Access Compliance Report

Public Rights-of-Way

(Curb Ramps)

Intersection ID: 44938	Main Street: NATHAN_DR	Cross Street: ACORN_FOREST_LN	Location: NW
ADA ID: A106AC1A4EE7	Ramp Type: PerpDiag	Initial Pass/Fail: Fail	Overall Compliance: No
Severity Score: 10			
Codes/Mitigation Info/Possible Solution		Field Measurements/Component Compliance

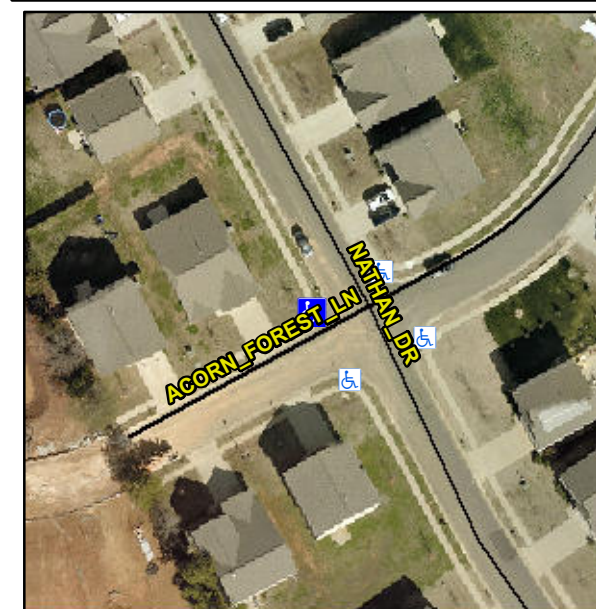
R304.5.1, R304.5.3

Compliance	Description	Data	Compliance	Description	Data
N/A	Ramp Length (in)	48.0	Yes	Ramp Slope (%)	5.8
No	Ramp Width (in)	47.0	No	Ramp XSlope (%)	2.6
N/A	Flare Type LT	N/A	N/A	Flare Type RT	N/A
N/A	Flare Slope LT (%)	N/A	N/A	Flare Slope RT (%)	N/A
N/A	Flare Traversable LT?	N/A	N/A	Flare Traversable RT?	N/A
N/A	Landing Length (in)	N/A	N/A	DWS Provided?	N/A
N/A	Landing Width (in)	N/A	N/A	DWS Contrast?	N/A
N/A	Landing Slope (%)	N/A	N/A	DWS Length (in)	N/A
N/A	Landing X Slope (%)	N/A	N/A	DWS Full Width?	N/A
N/A	Landing Curb? (Y/N)	N/A	N/A	DWS Offset (in)	N/A
N/A	Shared Landing?	N/A			
N/A	Gutter Ponding?	N/A	N/A	Gutter Slope (%)	N/A
N/A	Gutter Lip Ht (in)	N/A	N/A	Gutter X Slope (%)	N/A
N/A	Painted X Walk1?	No	N/A	Painted X Walk2?	No
	X Walk 1 Direction	To S		X Walk 2 Direction	To E
N/A	X Walk 1 Width (in)	N/A	N/A	X Walk 2 Width (in)	N/A
	X Walk 1 Slope (%)	0.6		X Walk 2 Slope (%)	4.6
	X Walk 1 X Slope (%)	2.5		X Walk 2 X Slope (%)	0.4

N/A	Ramp inside XWalk1?	N/A	N/A	Ramp inside XWalk2?	N/A
	Road Slope (%)	4.1	N/A	Clear Space?	N/A
	Road X Slope (%)	2.3	N/A	Clear Space to XWalk (in)	N/A
N/A	Any Obstructions?	N/A	N/A	Storm Grate/Utility Hazard?	N/A
	Obstruction Type			Storm Grate/Utility Type	
		N/A			N/A
		Yes		Surface Condition? (G/P)	Good

Remove & Replace Curb Ramp With Two New Directional Ramps or Equivalent.
